Subject: AP1000 COL Standard Technical Report Submittal of APP-GW-GLR-080 (TR 80)

Pursuant to 10 CFR 50.30(b), APP-GW-GLR-080, Revision 0, "Mark-up of AP1000 Design Control Document Chapter 7," Technical Report Number 80, is submitted as Enclosure 1 under the attached Oath of Affirmation.

1. APP-GW-GLR-080, Revision 0, "Mark-up of AP1000 Design Control Document Chapter 7,"  
Technical Report Number 80

Title: Mark-up of AP1000 Design Control Document Chapter 7

Figure 7.1-1

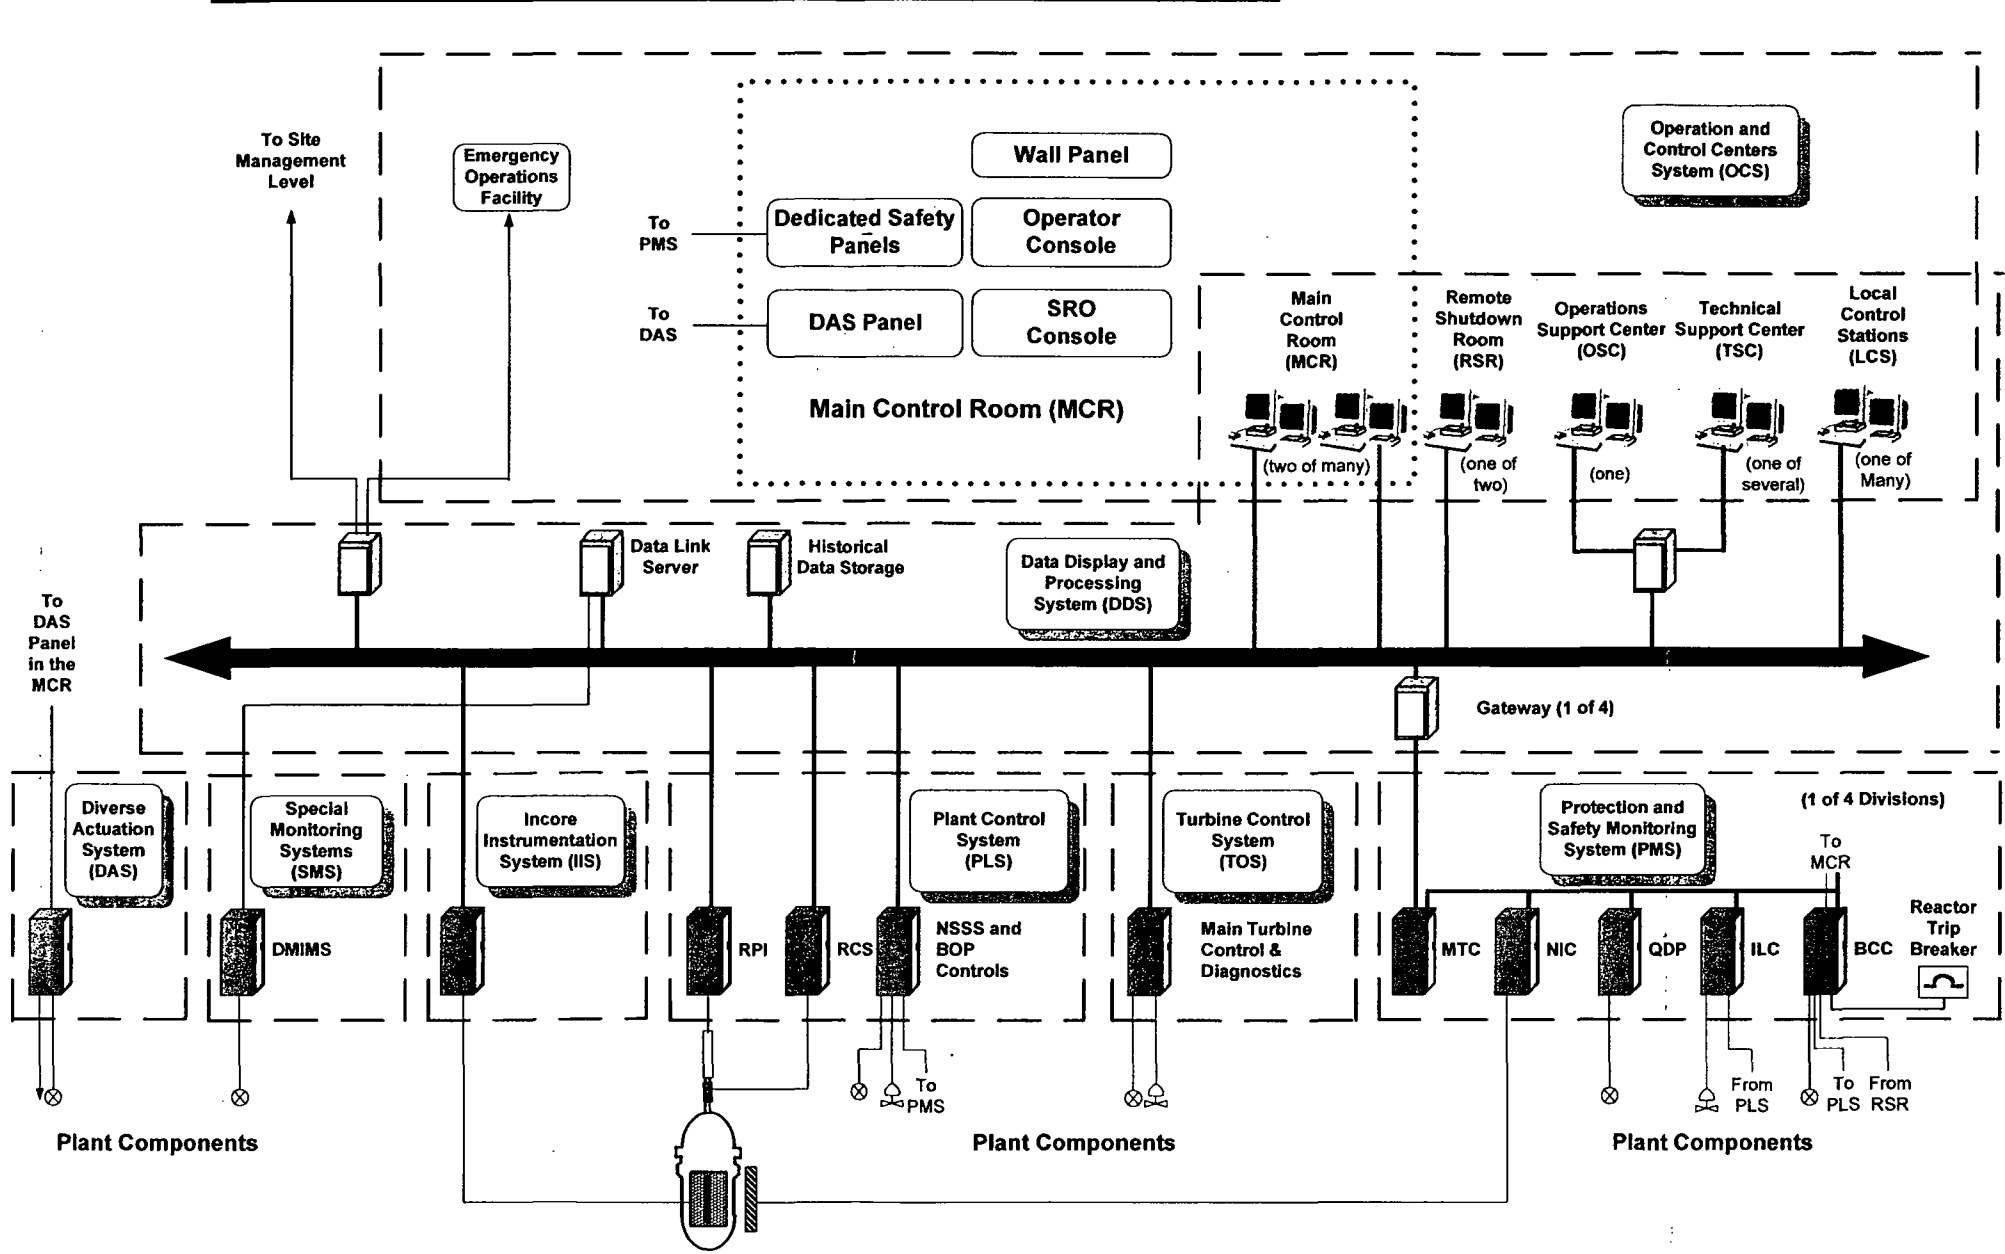
Figure 7.1-1 is revised to show the overall I&C Architecture consistent with the textual changes described elsewhere in this document. Figures 7.1-2 through 7.1-11 are deleted because the text that references them has been deleted or they are redundant to figure 7.1-1.
